McMullen Tank Control Valve & Yard Piping Improvements
Solicitation Number: CO-00172-SM
Job No.: 18-6005

ADDENDUM 3
March 20, 2019

MAP No. 140568	Compkey	SHEET E-03
SECT. No.	JOB No.	OF 7
DR. SL	CK. GBL	18-6005

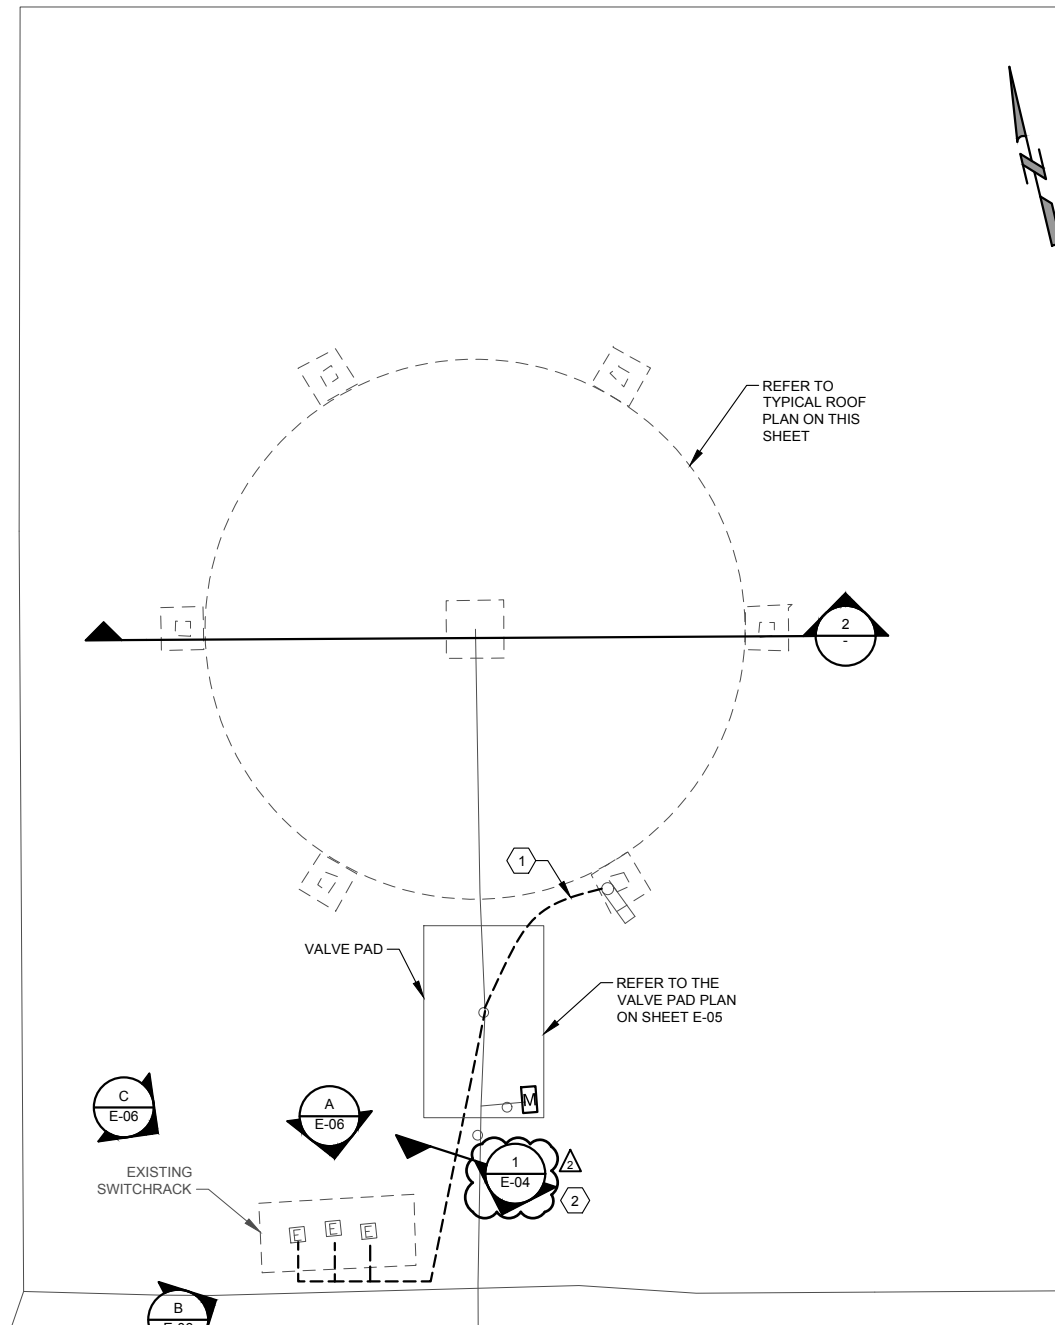
6. Electrical drawing E-03 note 27 state ground rods to be 316 stainless steel, however specification section 16660 section 2.03 a state it to be copper clad. Which is correct?

Copper-clad ground rods are to be used. See changes to plans.

- 27 ALL BARE COPPER GROUNDING CONDUCTORS SHALL BE TINNED, ALL GROUND RODS SHALL BE COPPER-CLAD STEEL, 3/4" BY 10' LONG. ALL EXPOSED COPPER GROUND CABLES SHALL BE GREEN INSULATED CONDUCTORS. PROVIDE XHHW INSULATION.

TANK PLAN NTS

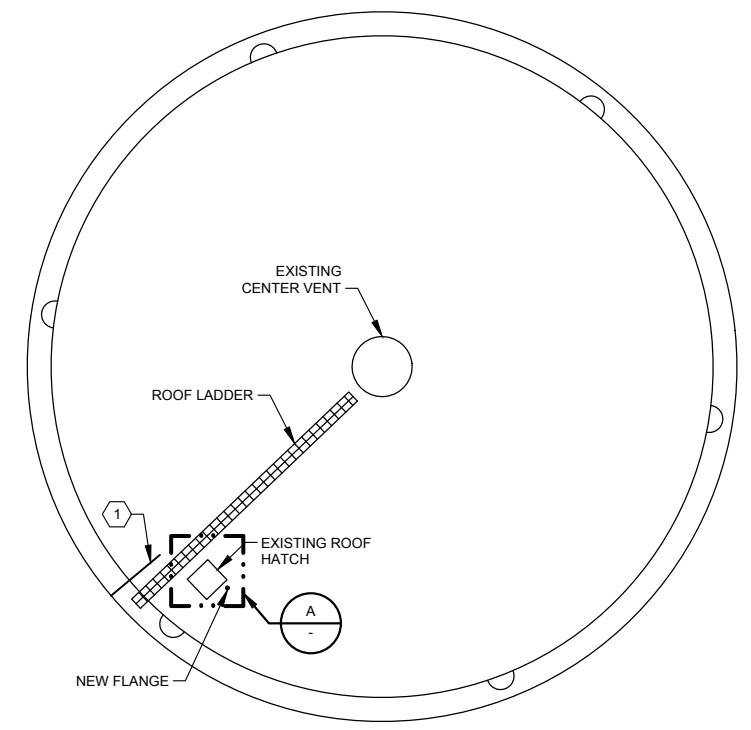
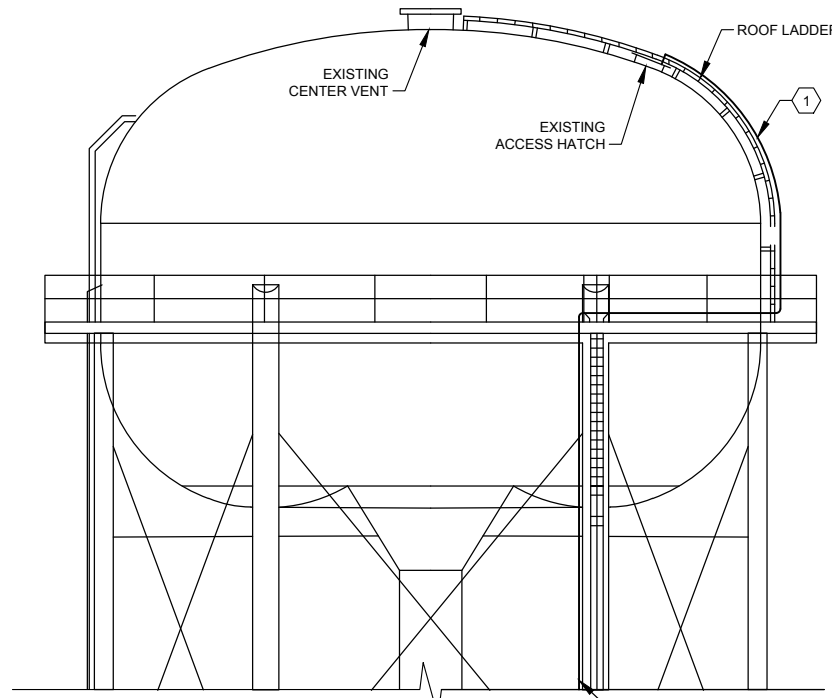
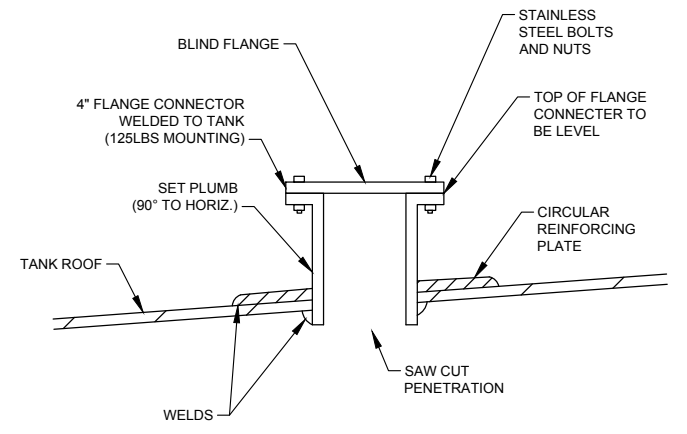
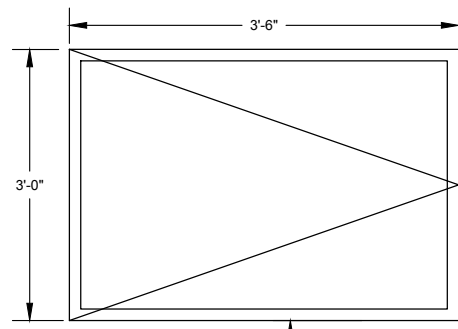
7. Scales on drawing E-04 for the Tank Plan and drawing E-05 are incorrect when comparing distance from the existing Switchrack to the storage tank and valve pad dimensions. Please verify that they should be 1/8"=2'0" and 3/8"=2'0" respectively and reissue.

The scale shown for the "Tank Plan" on Sheet E-04 (1/8"=1'0") and the scale shown for "Valve Pad Plan" on Sheet E-05 (3/8"=1'-0") are both incorrect. The correct nomenclature should be "NTS" for "Not To Scale". Those details are not based upon surveyed drawings and as such actual field dimensions are not necessarily displayed.
